GROUP	MODEL
BOD	2020-2025MY Soul (SK3)
NUMBER	DATE
337	March 2025

## TECHNICAL SERVICE BULLETIN

SUBJECT: **HORN ASSEMBLY INSPECTION/REPLACEMENT (WTY041)**

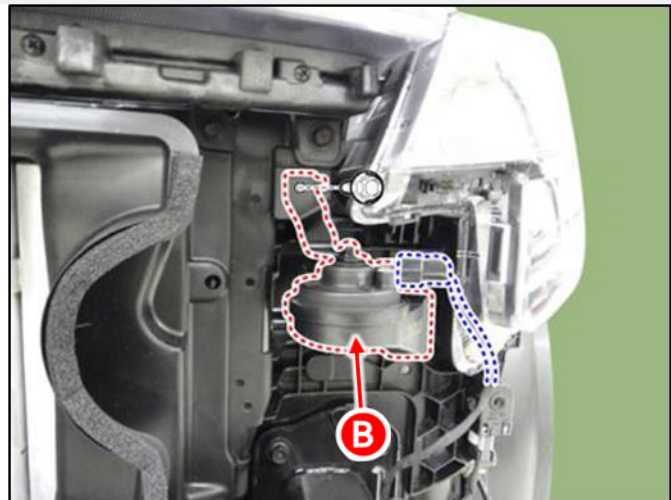
### Inspection Procedure:

- Press the Horn Pad (A) to confirm normal operation:
  - If the horn operates **normally**, this TSB does not apply. **Claim inspection only labor op 242200R0.**
  - If the horn is **inoperative** or the **tone is distorted**, proceed to the 'Replacement Procedure' below.

### Replacement Procedure:

- Replace the Horn (B) by referring to "Body Electrical System → Horn → Repair procedures" in the applicable Shop Manual on KGIS.

- Reinstall all removed parts in the reverse order of removal.
- Confirm normal operation.
